Village of Arlington Heights
Plan Commission
Board Room
Arlington Heights Village Hall
33 S. Arlington Heights Road
Arlington Heights, IL 60005
September 30, 2015
7:30 PM

- A. The Moorings - 811 E. Central Rd. - PC#15-012
PUD Amendment
- B. Collision Damage Experts - 9 E. College Dr. - PC#15-018
Land Use Variation

VOLUME I CIVIL DRAWING NO.: 2014104 COMMISSION NO.: 2014104		RENDERING DATE: 06/26/2015 SCALE: AS NOTED		REVISIONS NO. DATE DESCRIPTION		FOR THE MOORINGS OF ARLINGTON HEIGHTS PRESBYTERIAN HOMES 811 EAST CENTRAL ROAD, ARLINGTON HEIGHTS, IL 60005 DRAWN BY: J.S.D. COORDINATED BY: C.S.L. CHECKED BY: J.F.H. APPROVED BY: C.P.K.		rtps architects® architecture • master planning • interior design 250 VALLEYBROOK DRIVE, LANCASTER, PA 17601 717-560-9501 FAX: 717-560-2373 RLPS, LLP		PLANNING COMMISSION SUBMISSION	THIS DRAWING IS AN INSTRUMENT OF SERVICE. IT IS THE PROPERTY OF RLPS ARCHITECTS, P.C. AND IS NOT TO BE REPRODUCED WITHOUT THE ARCHITECT'S PERMISSION AND UNLESS IT BEARS THE NAME OF THE ARCHITECT. CONTRACTOR SHALL VERIFY ALL DIMENSIONS AND CONDITIONS AT THE SITE BEFORE PROCEEDING WITH THE WORK.	
--	--	--	--	-----------------------------------	--	--	--	--	--	----------------

TREE SURVEY / PRESERVATION PLAN

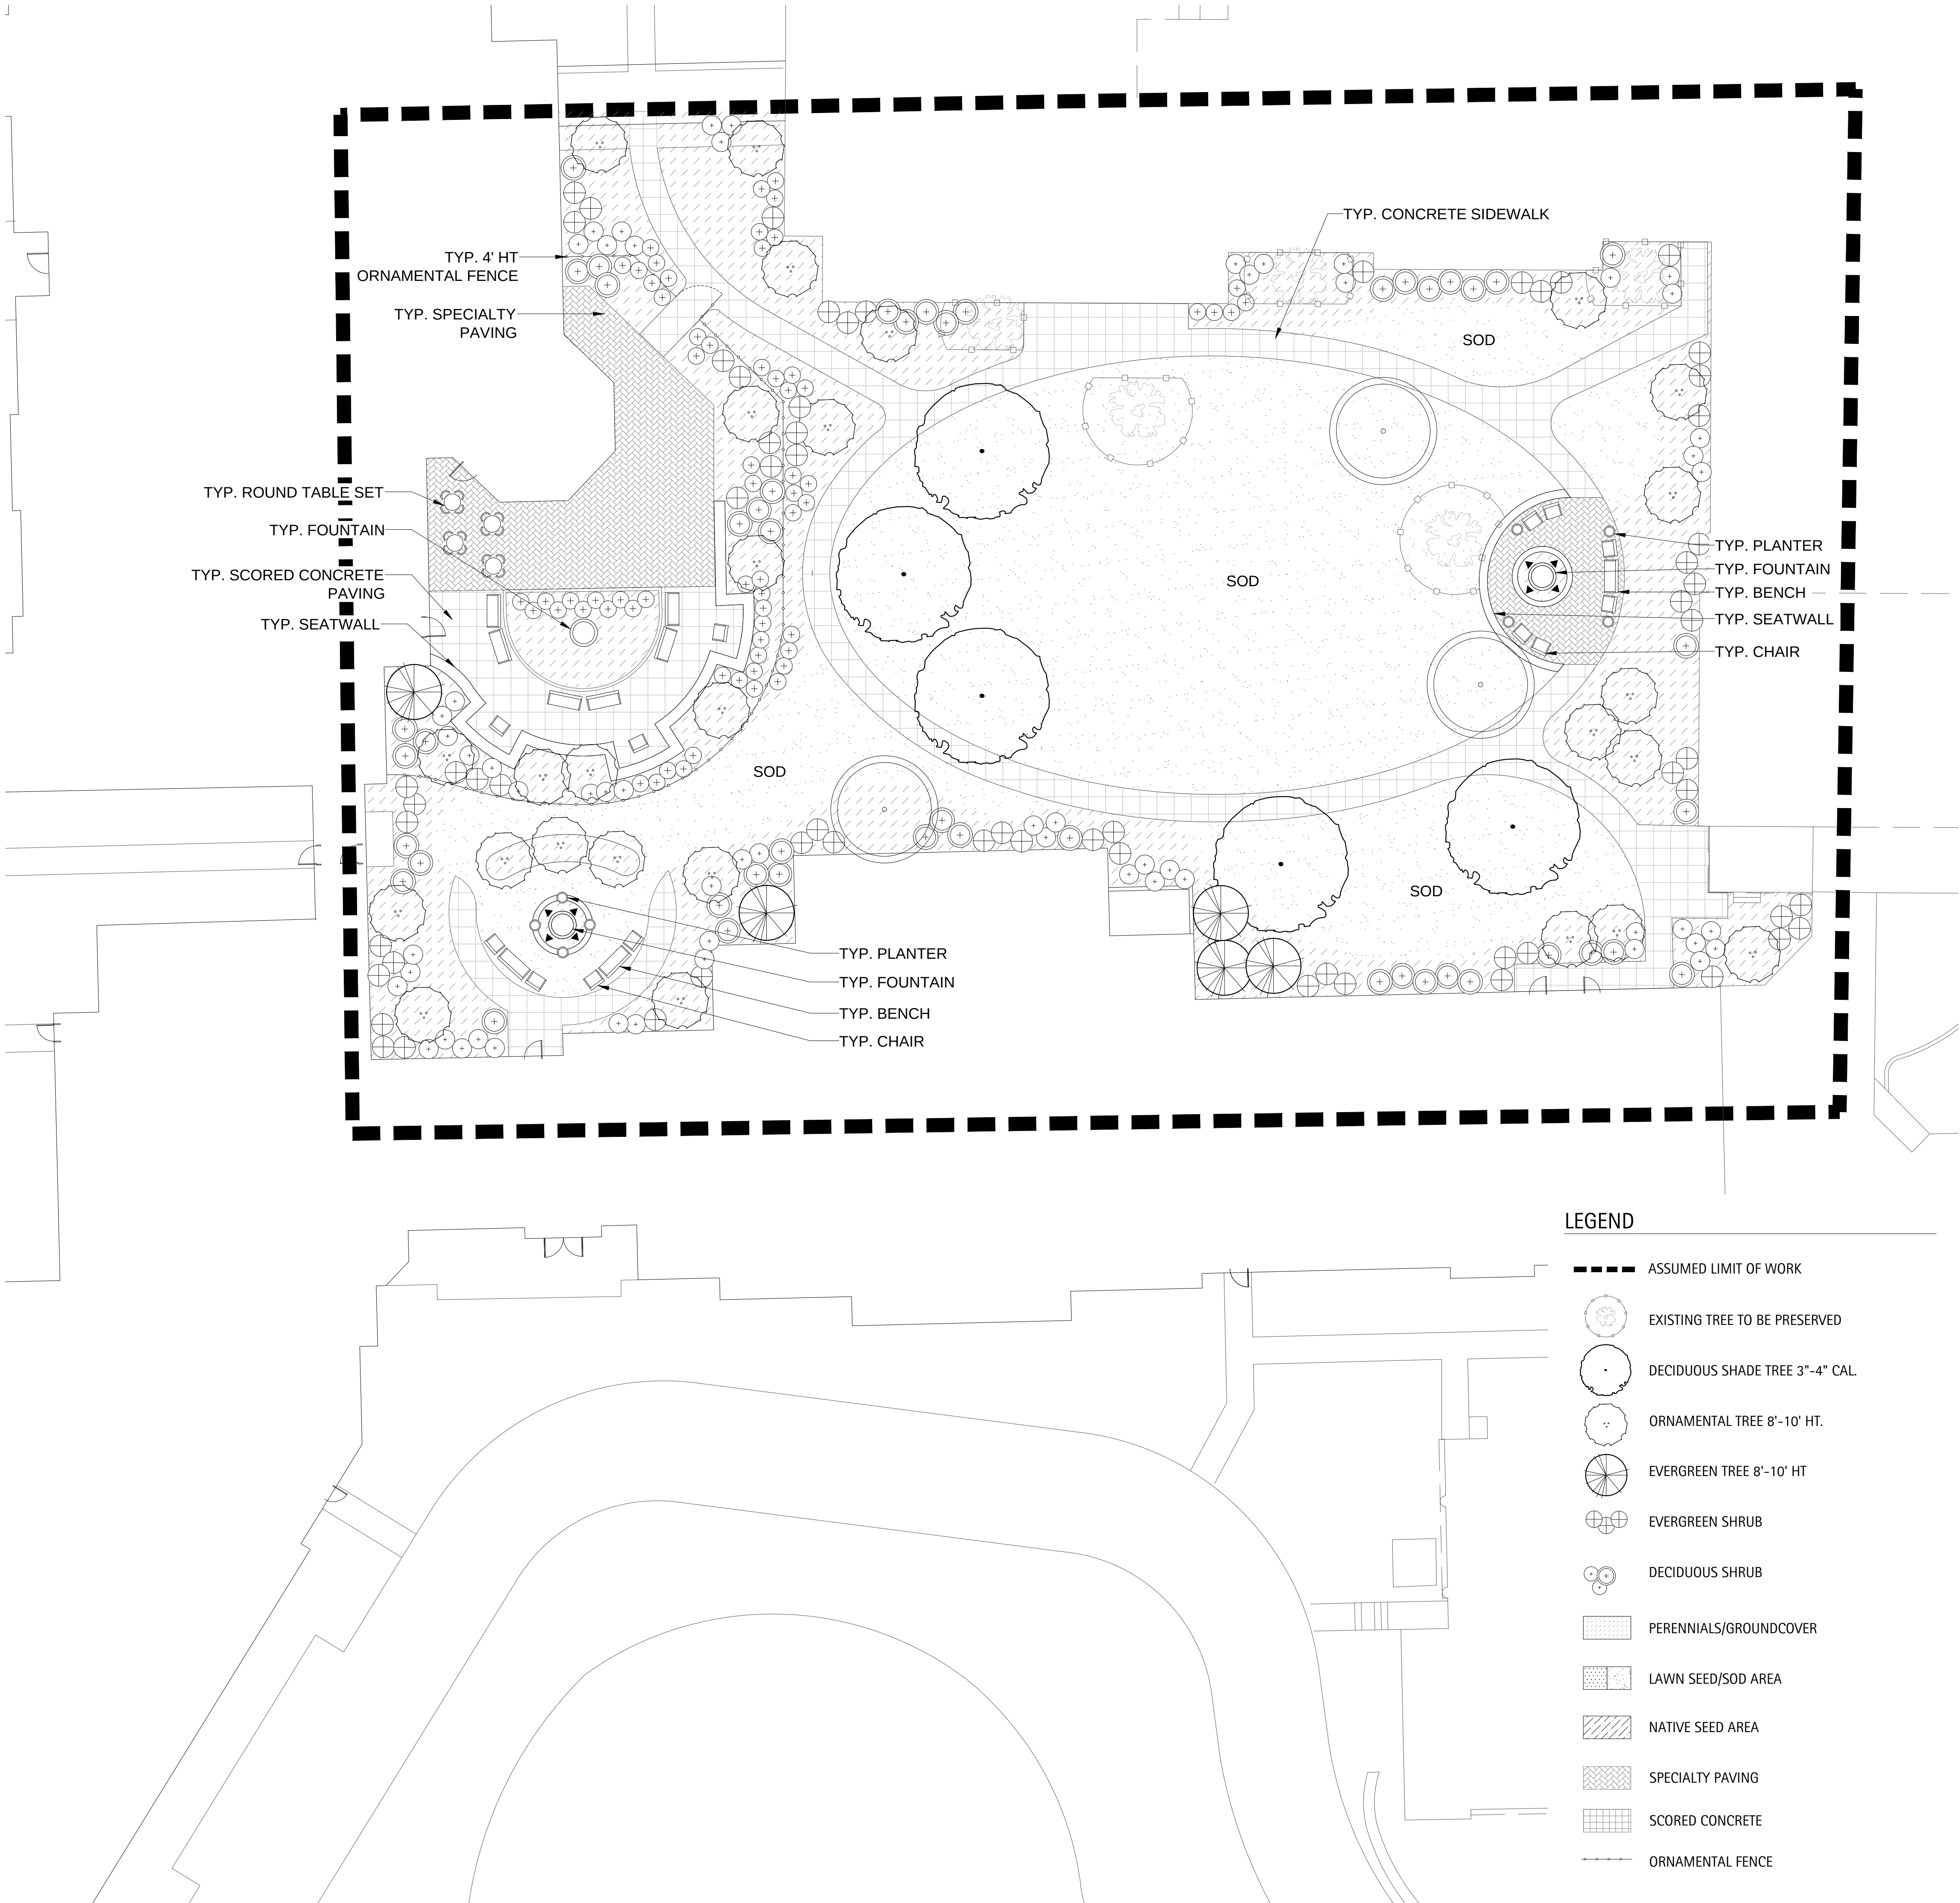
- 1) Approximately 164 trees on the site are identified for removal. On the tree inventory on sheet L-01 please include the disposition for each tree. Also, on the plan increase the size of the tree number/tag so that it is legible.
- 2) Are there additional trees that could be preserved? It is recommended that additional trees be preserved adjacent to west lake and near the court yard (Zone B - Fellowship Hall). Please reevaluate the trees proposed for removal. Also, explore options for transplanting some of the trees elsewhere on the site.

1. Sheet L-01 has been updated to reflect requested changes.
2. While most of the trees planned for removal fall within new building/paving/wall or retention pond areas, some additional trees outside of these areas may require removal due to proposed site grading. Opportunities for preservation of additional trees will be further evaluated as civil engineering and grading plans are refined through the design development and construction documentation process. Identification of potential transplants will also be explored during subsequent refinements to landscape plans.

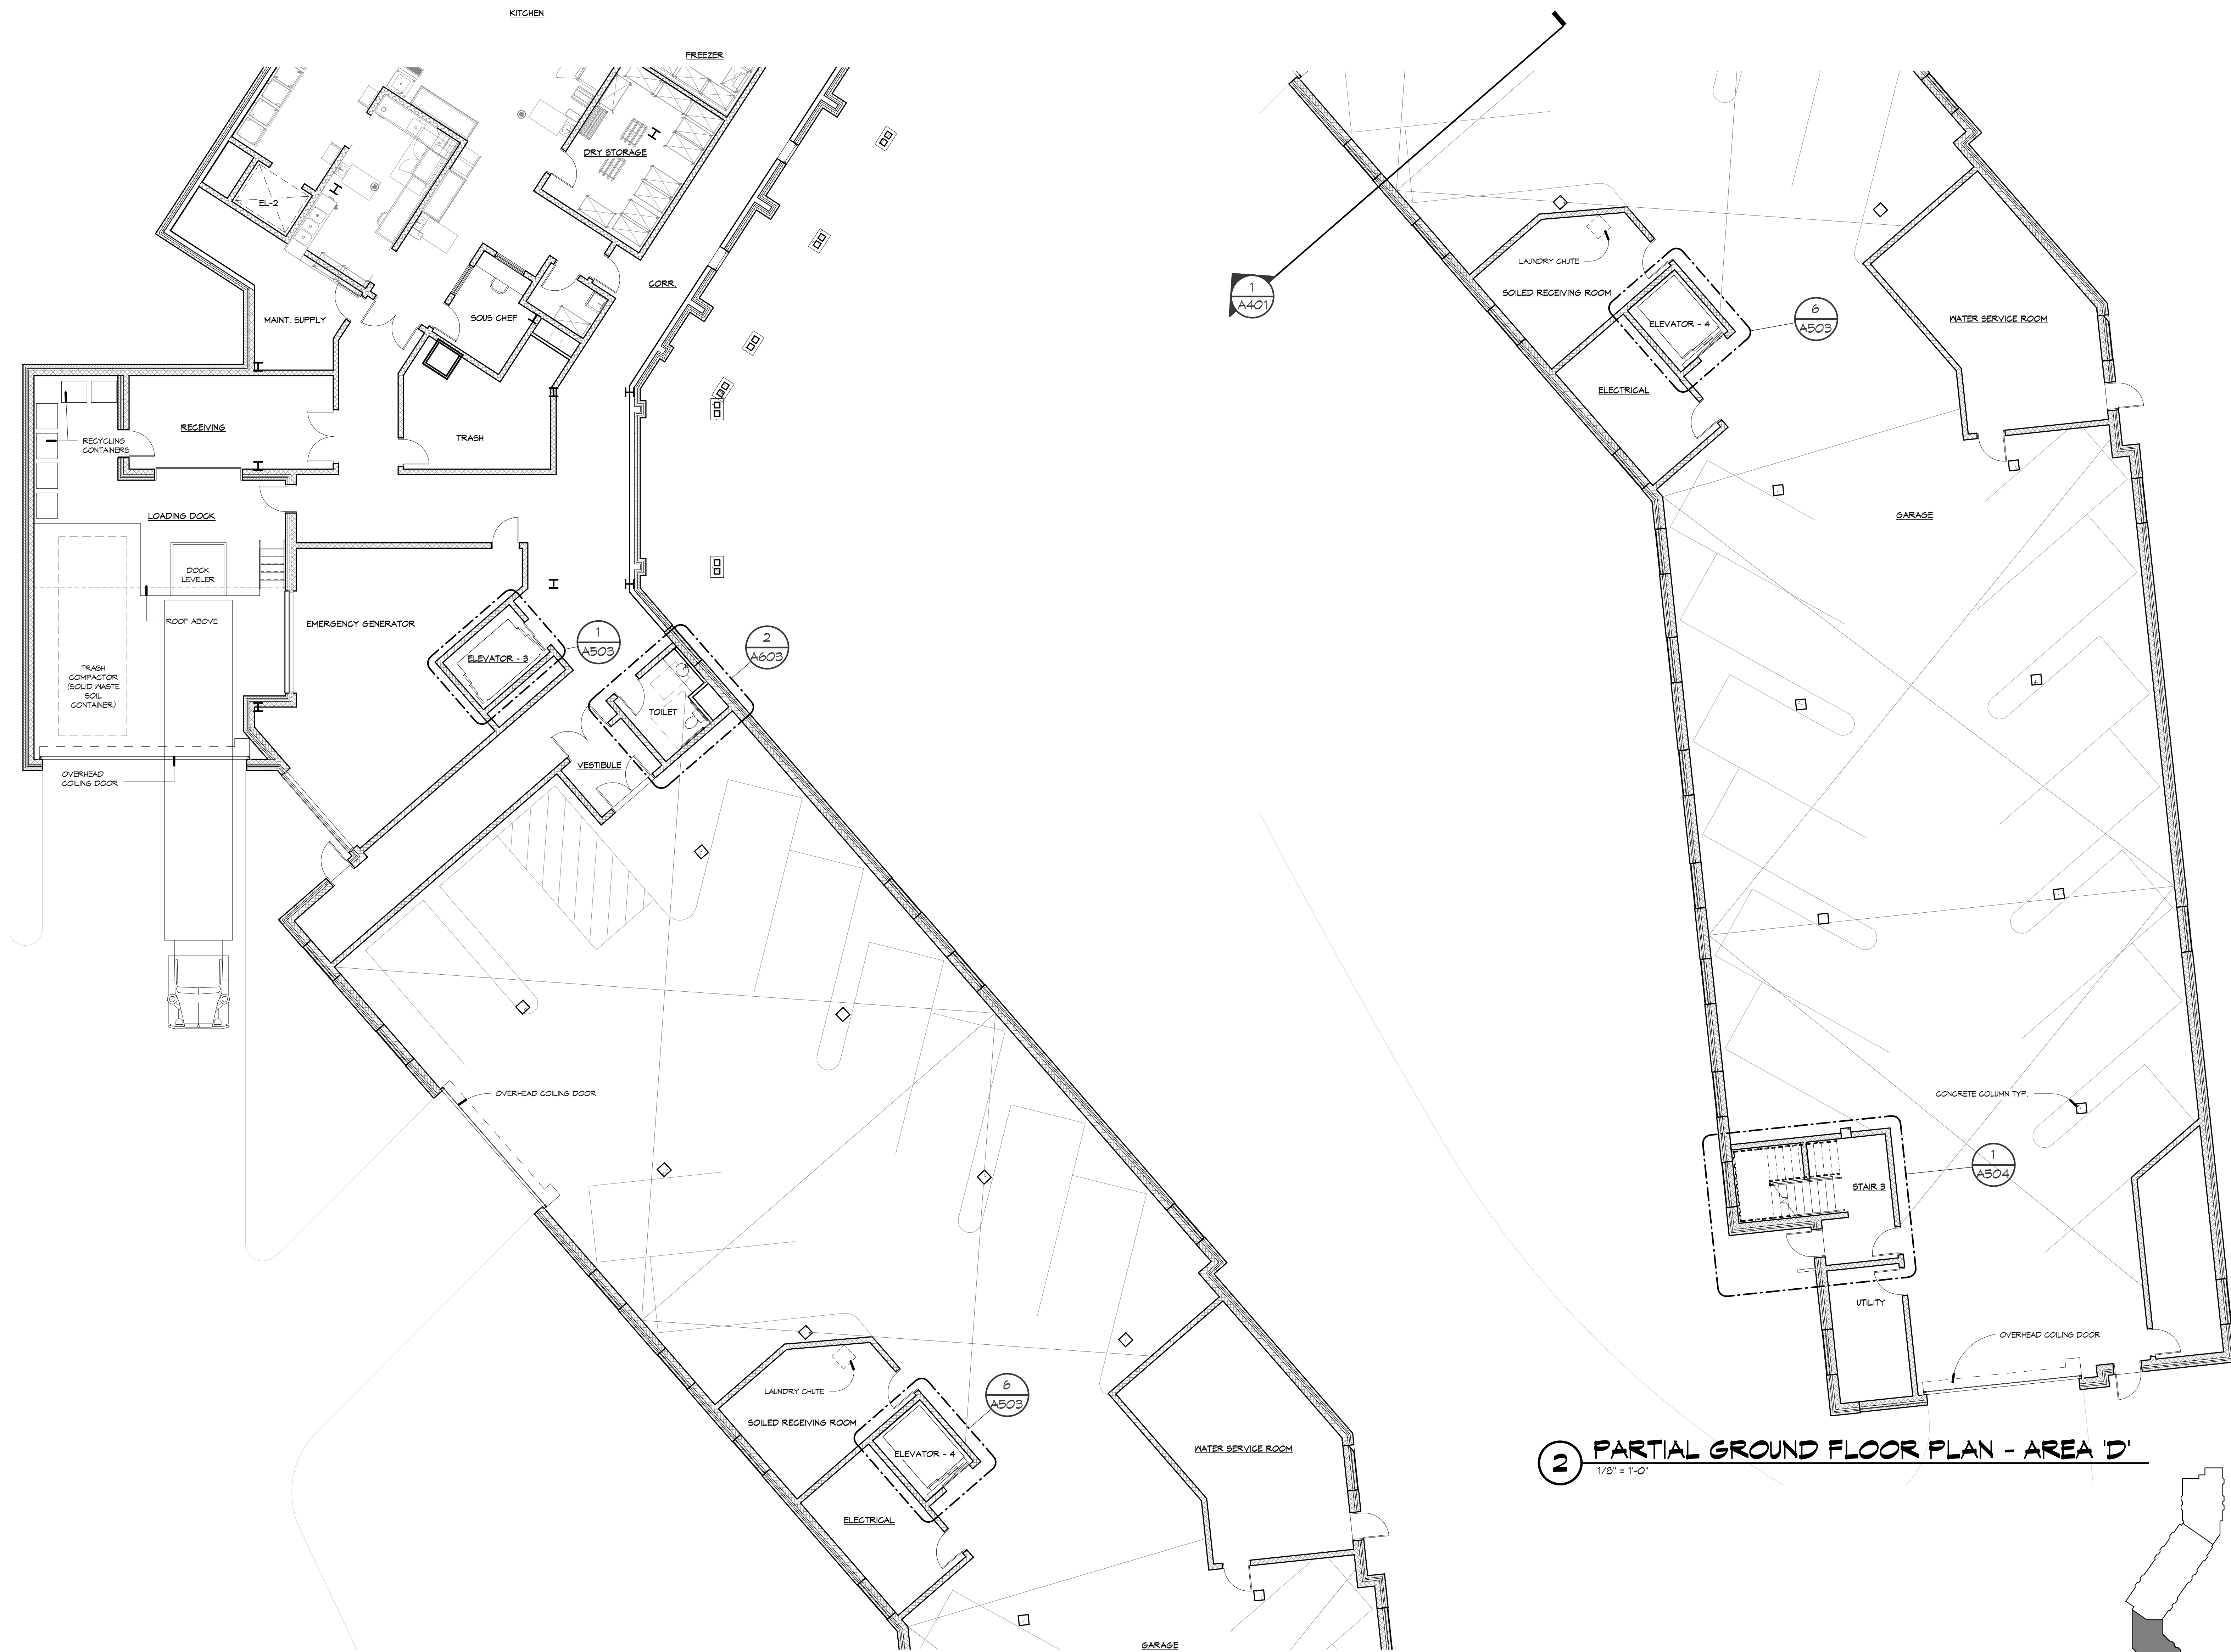
19. Sheet A002, Ground Floor Plan: When backing out of the first underground parking space, the garage door will need to open.

17. The restrictor plate detail has been revised to show a concrete baffle wall. See sheet C7.0.
18. No response required.
19. The garage plan has been revised. See attached Assisted Living drawing A102.

1. There is a solid waste soil container (compactor) included in the dock area. We've included an updated drawing noting this location. See Assisted Living drawing A102
 - a.) The area accommodates the compactor selected by the owner.
 - b.) The location of the container is in the dock area. The surface is concrete. The area slopes to a linear drain.
 - c.) The dock area is fully enclosed by walls and an overhead door.
2.
 - a.) There is sufficient space for a truck to access this area.
 - b.) This container is in the dock area. Sufficient clearance is provided for access vehicles.

22. The loading berth is provided in the Assisted Living building. See attached Assisted Living drawing A102.
